Subject: Limerick Generating Station, Units 1 and 2
Response to Request for Additional Information Concerning
Technical Specification Change Request No. 93-19-0

Response to Request for Additional Information Concerning Technical Specifications Change Request No. 93-19-0 Submitted to Increase the Spent Fuel Pool Storage Capacity

FIGURE 11.1

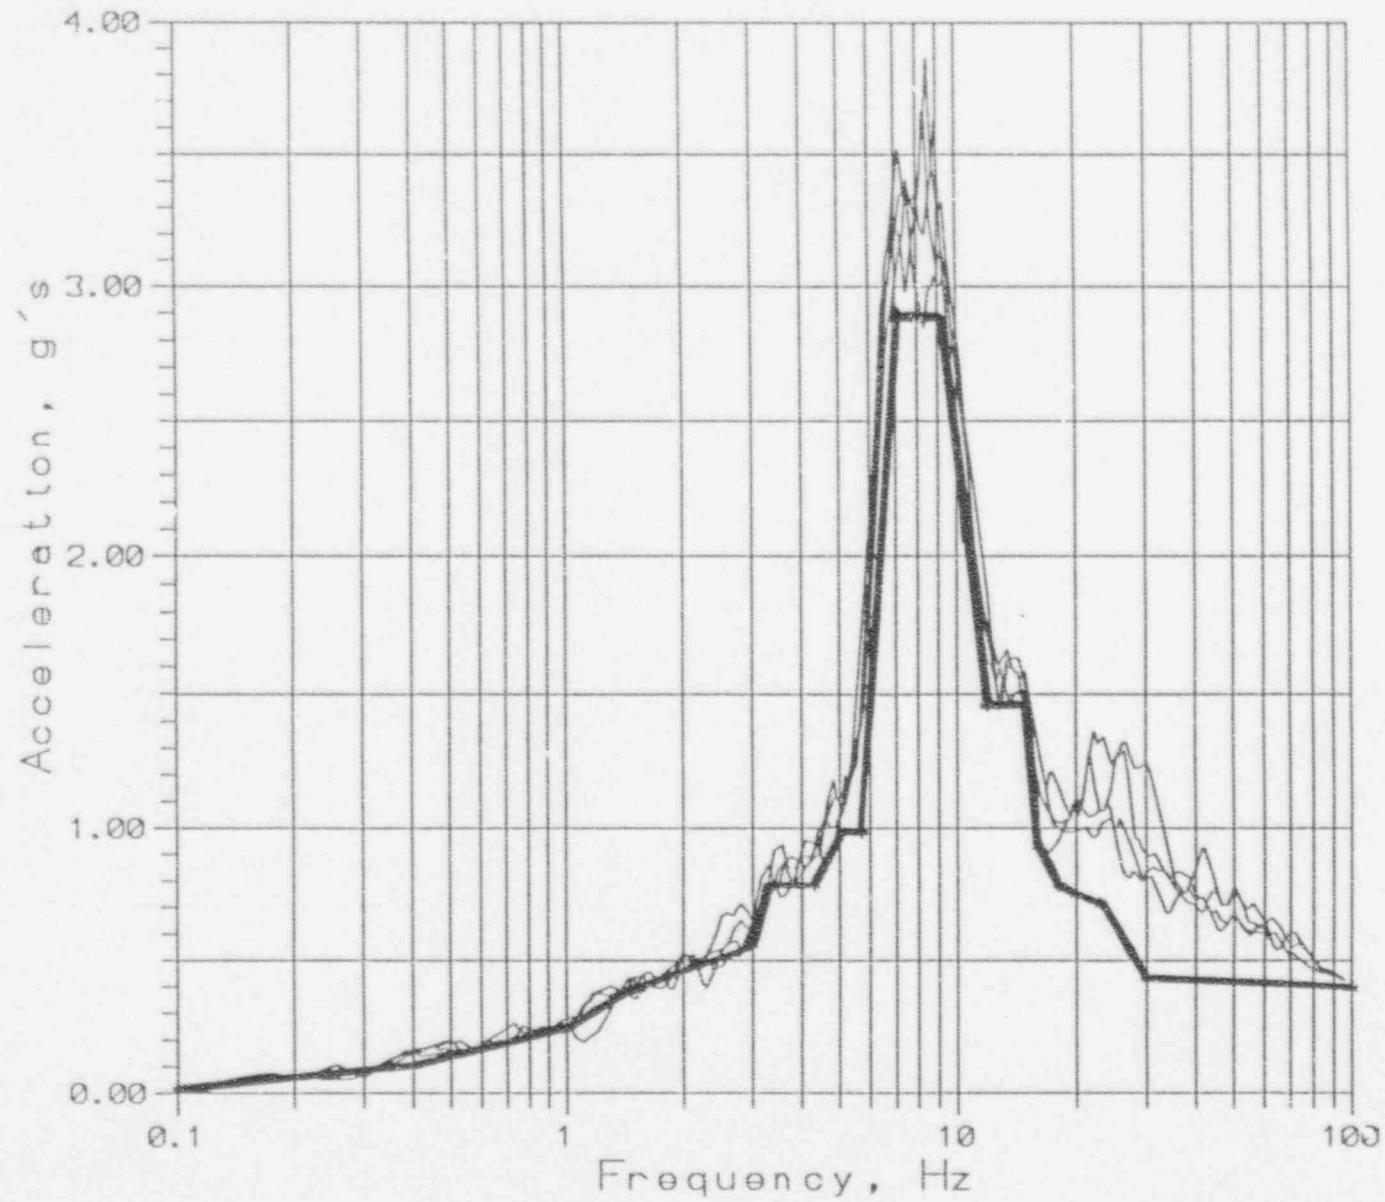
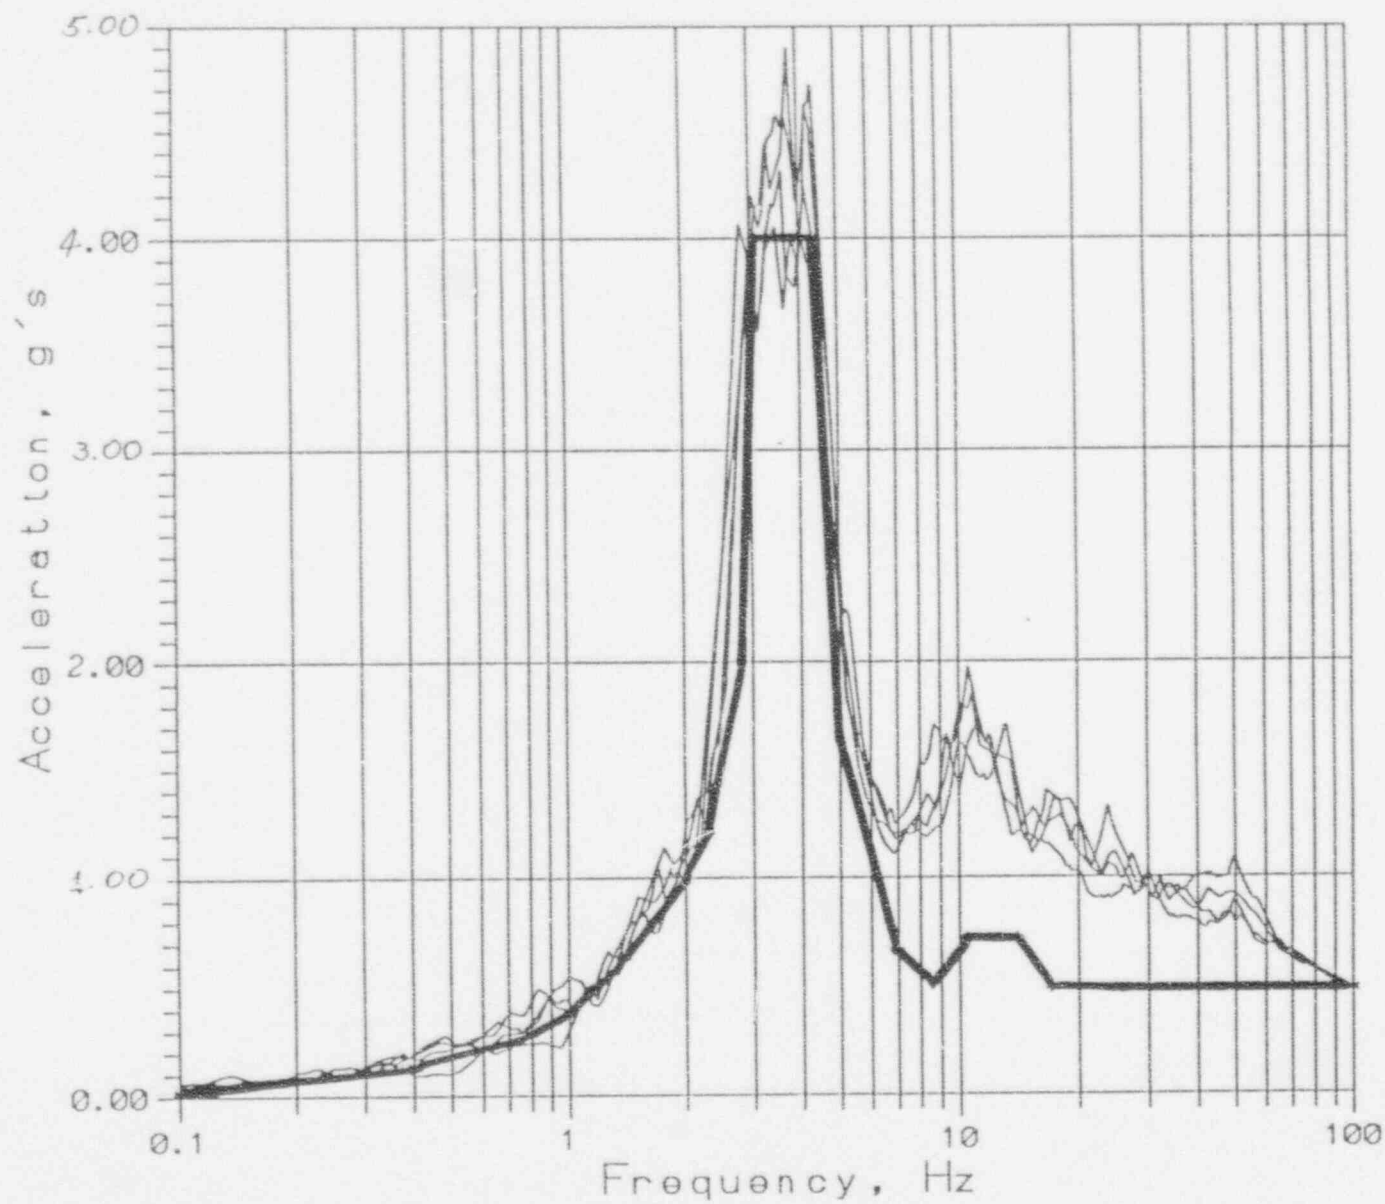
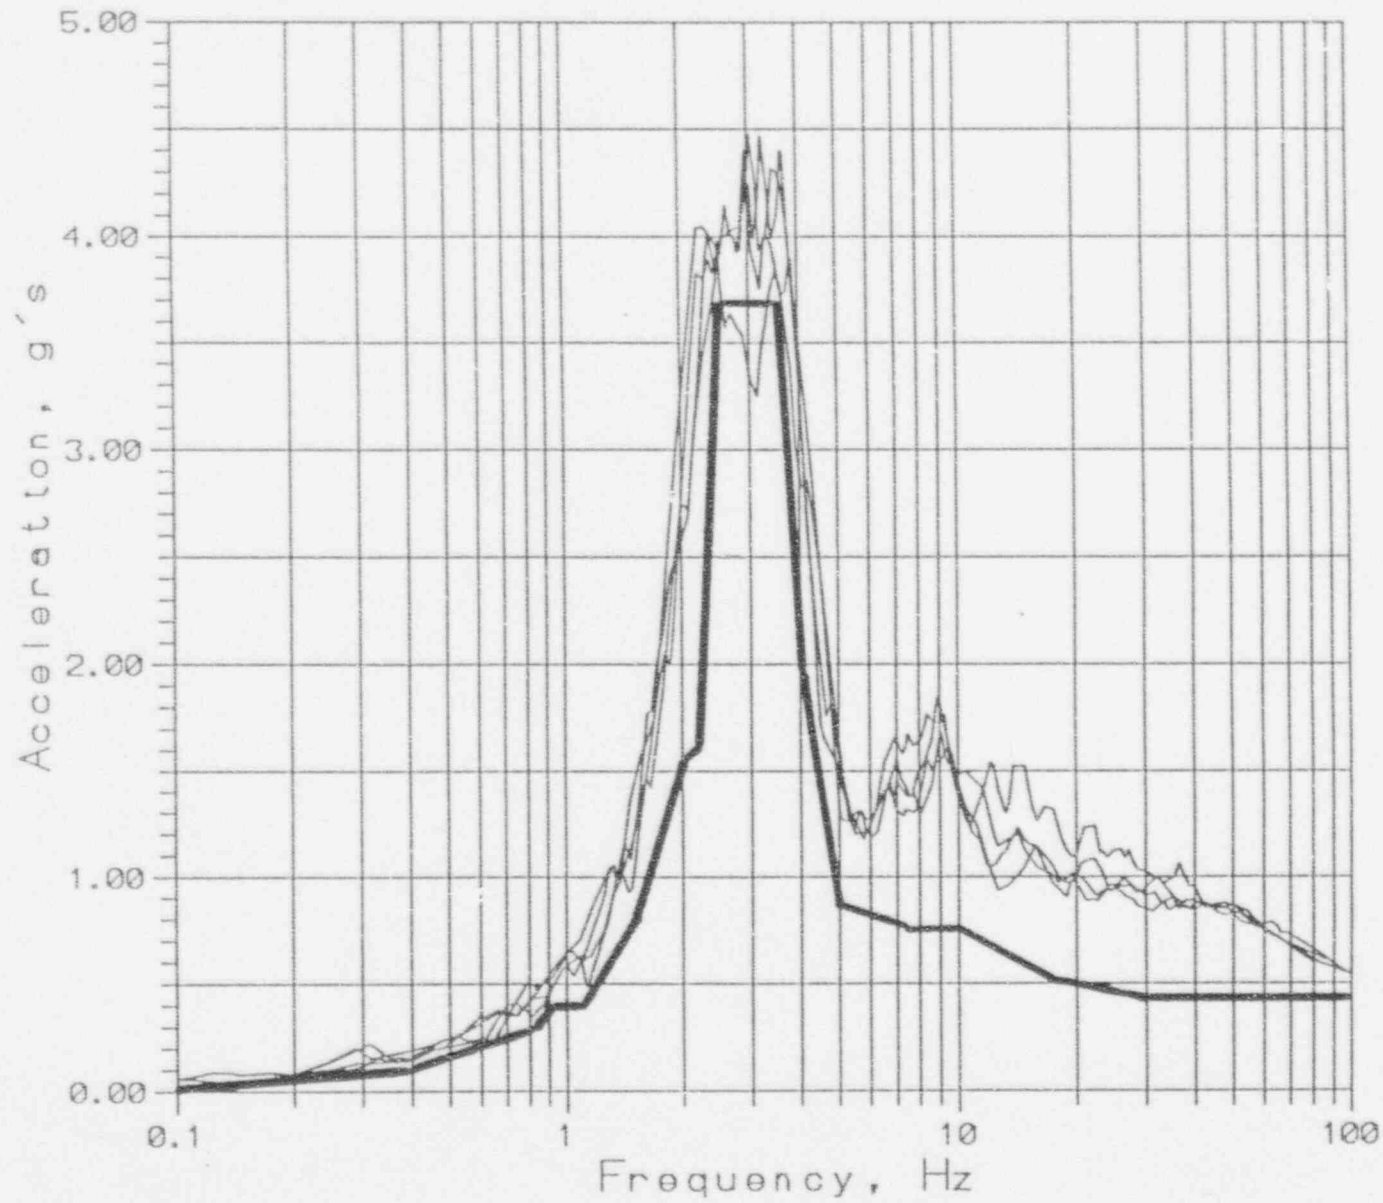
- d. Provide the four response spectra developed from the four artificial time histories and compare them with the design response spectrum of the FSAR.
- e. Discuss the basis for selecting Time History No. 2 over the Time History No. 3 in the SSE analysis. Provide justification that Time History No. 2 is more conservative than the No. 3.
- f. Provide the digitized artificial time histories representing the input motions at the spent fuel pool floor, which correspond to the SSE and operating basis earthquake (OBE), in a 3.5-inch diskette for use by the staff in performing an independent analysis.

- d. Figures 11.1 through 11.3 show the comparison of the three (3) components of four (4) individual regenerated response spectra from the four (4) corresponding SSE artificial time-histories with the design target spectra. Please note that SRP Section 3.7.1 only requires that the average calculated response spectra generated from the multiple time-histories to envelop the design response spectra. The response spectra calculated for each individual time-history need not envelop the design response spectra.

FIGURE 17.2

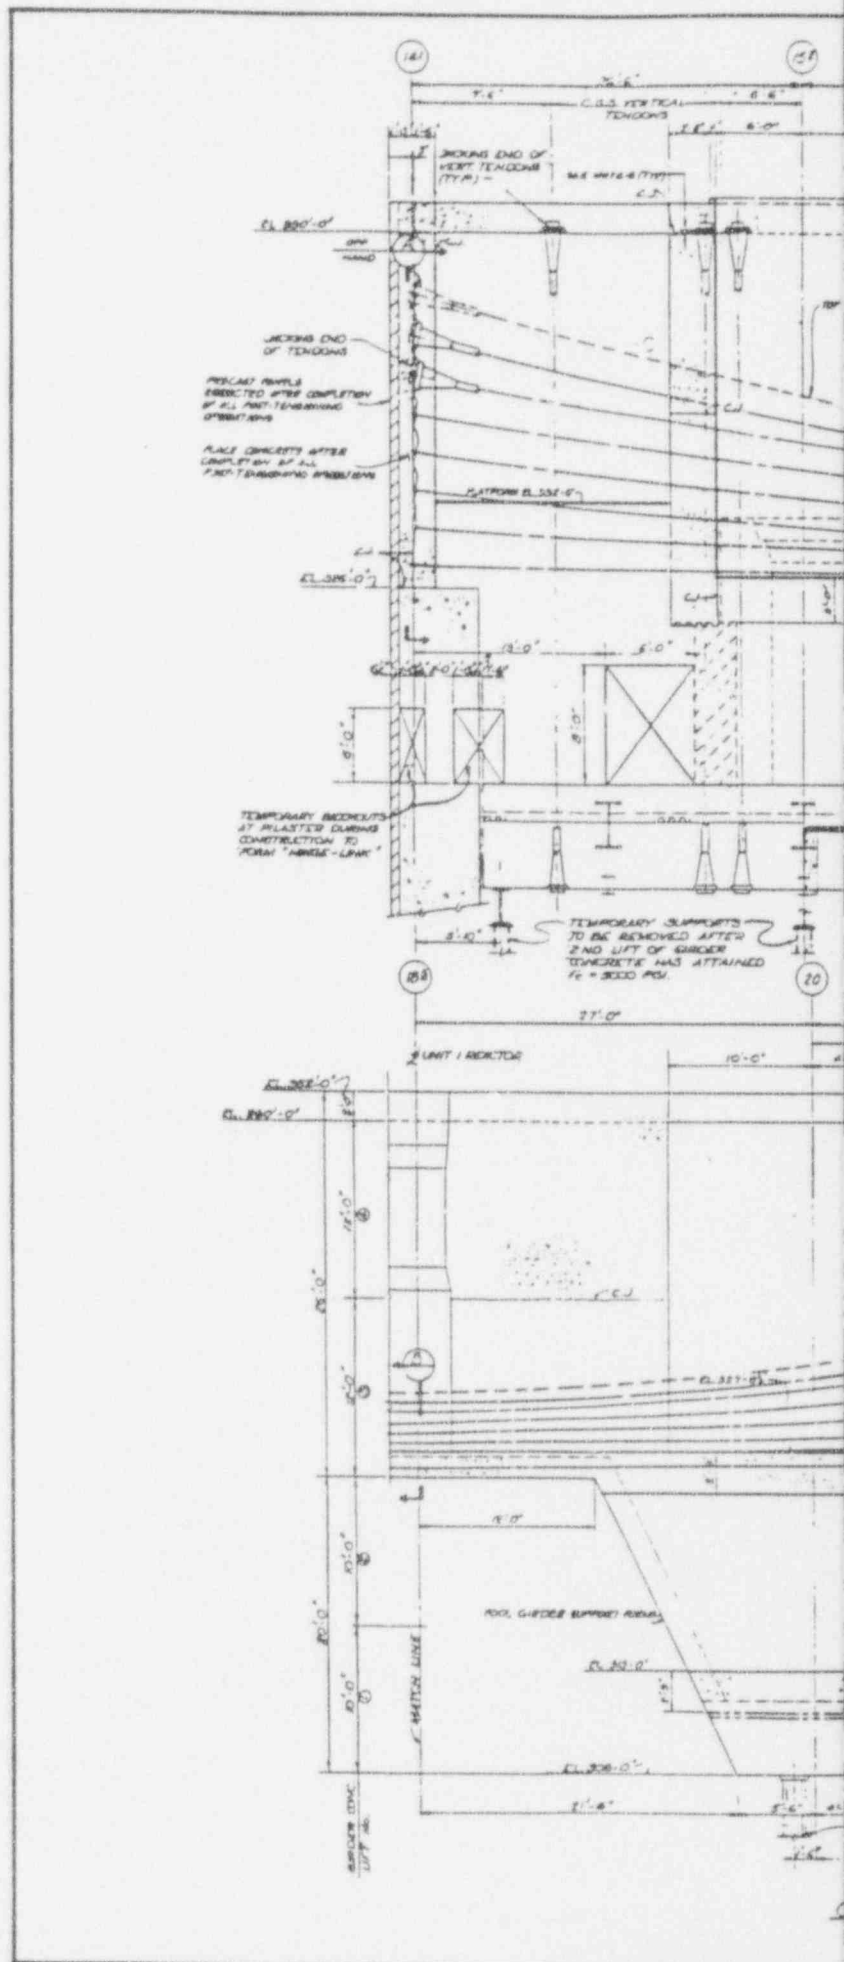
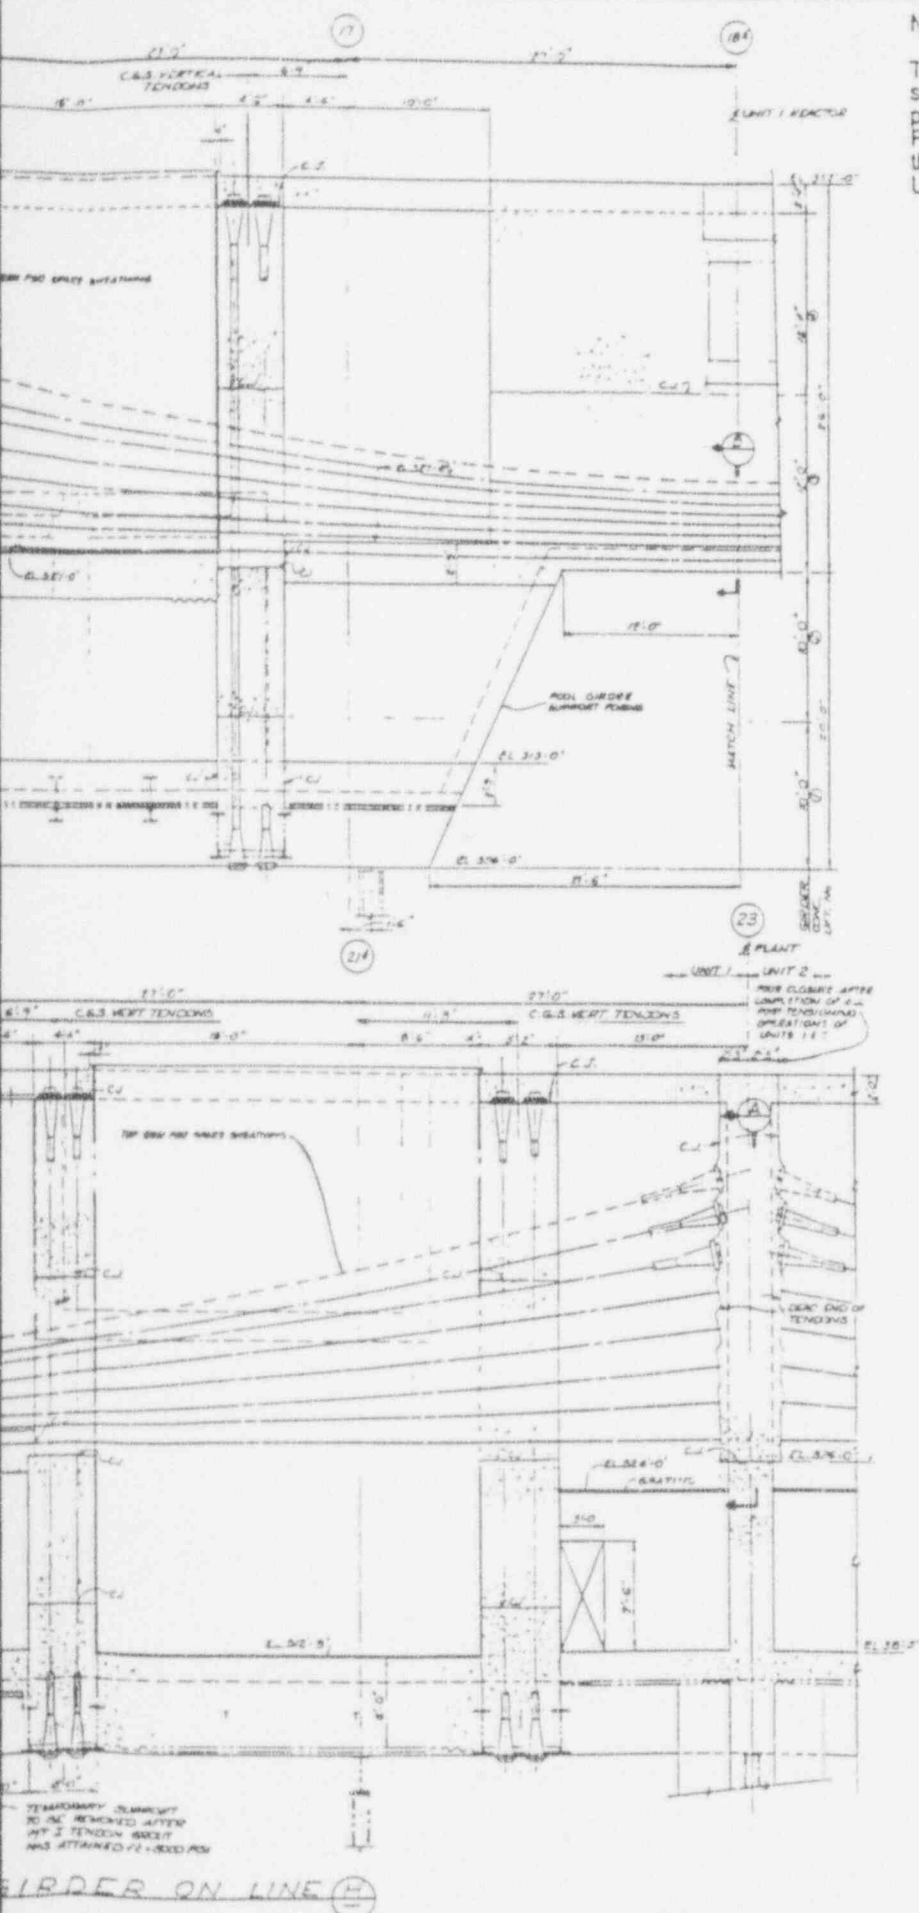
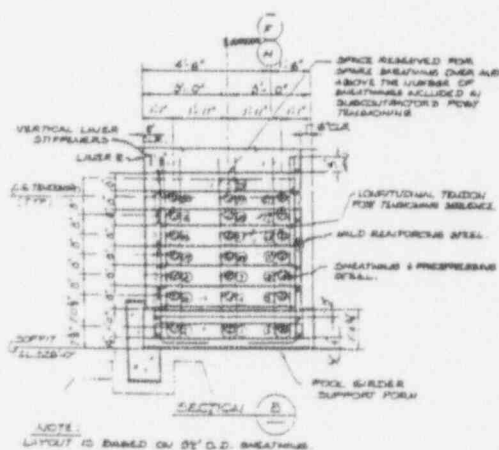
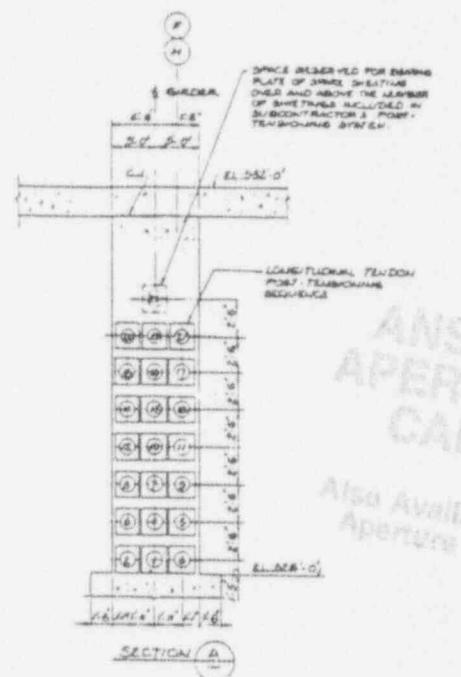
- 1. Description of spent fuel pool structures including an explanation of the support mechanism for the pool slabs.
 - 2. Key assumptions.
 - 3. Material properties.

Refer to LGS UFSAR Figure 3.8-53 and Figure 3.7-18 (see Figures 17.2 and 17.3).
